AMENDMENT TO FACILITY OPERATING LICENSE

Amendment No. 35
License No. DPR-71

SAFETY EVALUATION BY THE OFFICE OF NUCLEAR REACTOR REGULATION

3/4 2-2

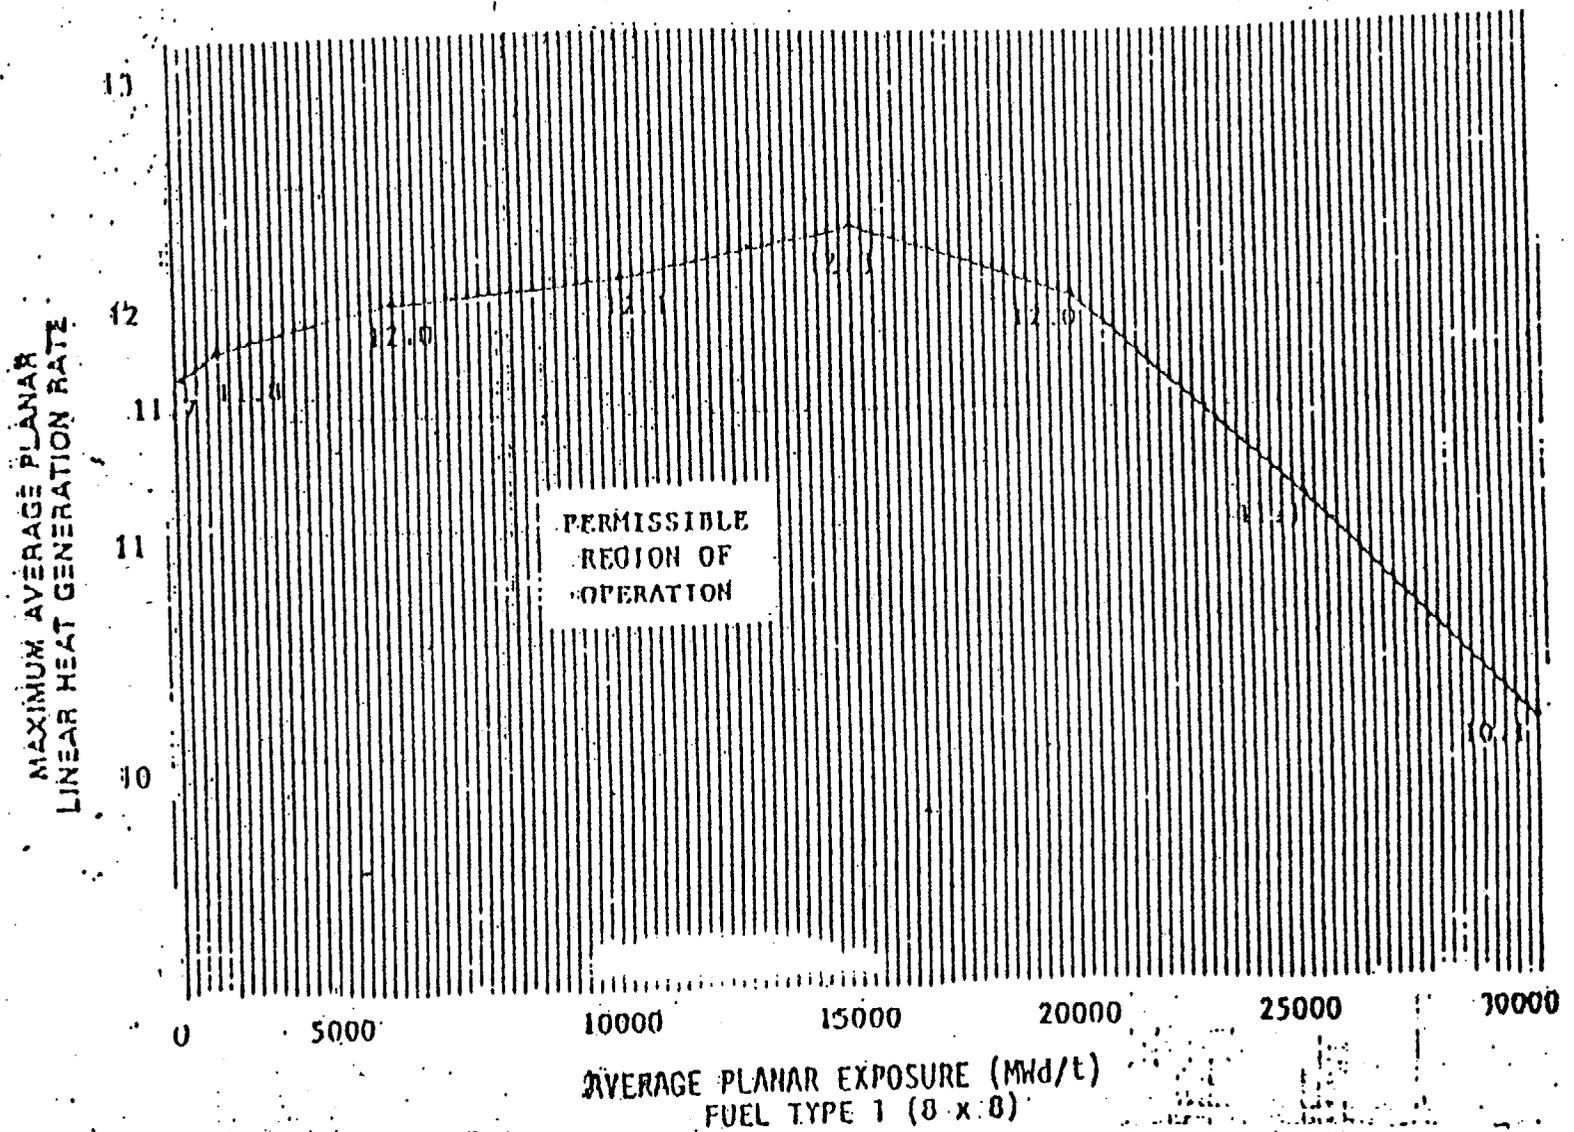
*In single reactor recirculation loop operation, the APLHGR limit shall be reduced to .65 of the values specified in the above tables. This portion of the Specification expires on March 15, 1981.
